REF: N209580

DATE: 31 March 2021

RE: 25 DUNHEVED CIRCUIT, ST MARYS – TRAFFIC IMPACT ASSESSMENT PEER REVIEW

Figure 4: Available storage capacity for articulated vehicles

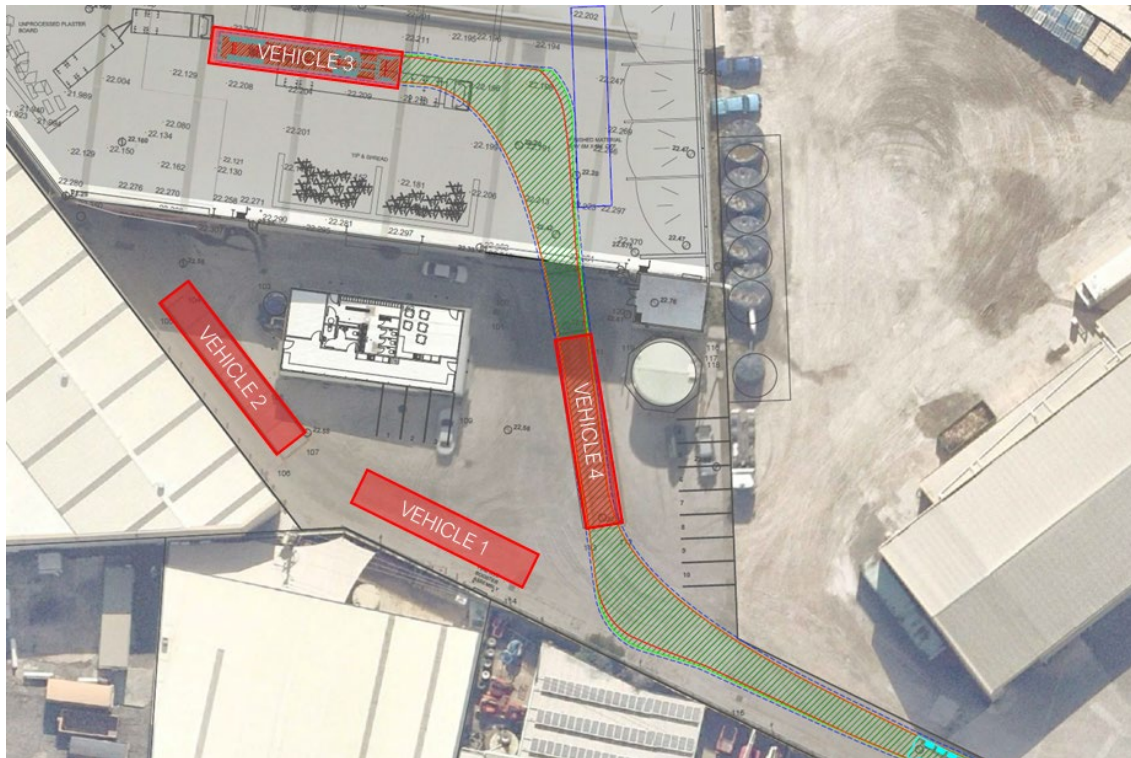
- The queuing assessment states that the driveway access is about 100 metres long, allowing the site to accommodate up to seven semi-trailers or nine rigid trucks at any one time, including one vehicle on the inbound weighbridge and one vehicle in the facility. That said, the swept path assessment indicates two-way passing between inbound and outbound articulated vehicles is likely not possible at each end of the driveway and along the driveway itself. As such, the site would likely only be able to accommodate up to four articulated vehicles at one time, as shown in Figure 4. While this would still suitable accommodate the anticipated demand for a typical day, no assessment has been completed for a 'busy day' and therefore the potential higher traffic generation associated with busy processing periods may result in vehicles queuing on Dunheved Circuit.

- A 20 metre articulated vehicle should be used as the largest design vehicle requiring access to the site.
- The queuing assessment should be updated to also consider a 'busy day' scenario to ensure no queuing would occur on Dunheved Circuit or impact exiting vehicles.
